W3F1-2014-0025

June 11, 2014

**SUBJECT:** Updated Responses to Request for Additional Information Regarding Adoption of National Fire Protection Association Standard NFPA 805 License Amendment Request (LAR) Waterford Steam Electric Station, Unit 3 (Waterford 3)  
Docket No. 50-382  
License No. NPF-38

### **RAI FPE 10**

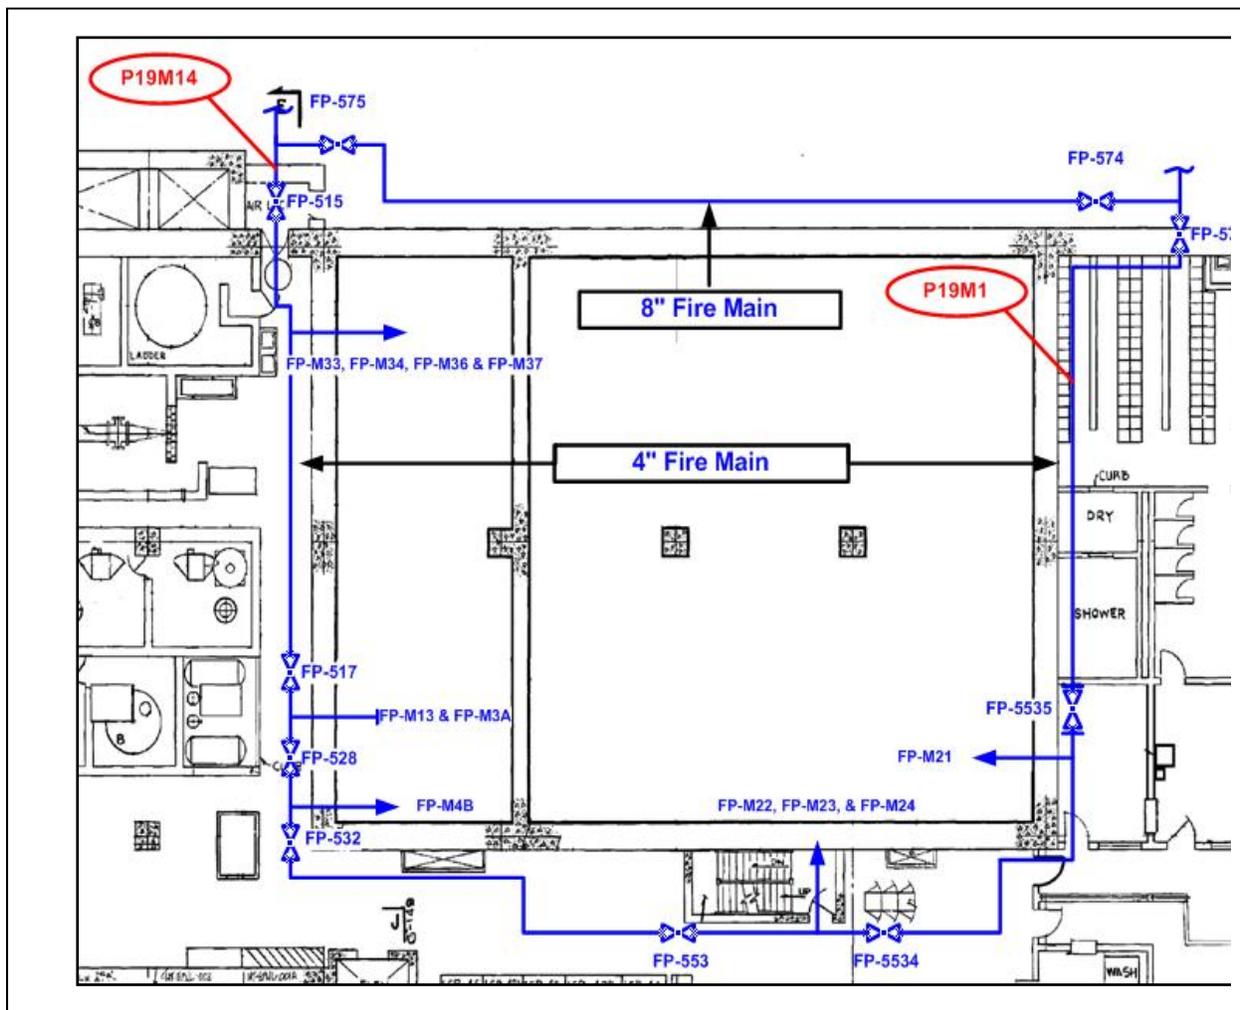
*Attachment L, Approval Request 6 -A deviation from NFPA 805 Section 3.5.1 is requested for several plant areas where the fire water supply demand is not met with the least demanding portion of the main loop out of service. Please justify this deviation to include a discussion of the following:*

- a. The location of this 4" loop section.*
- b. The procedures in place to mitigate.*
- c. The capacity of the three sprinkler systems given the least demanding portion of the main loop is out of service.*
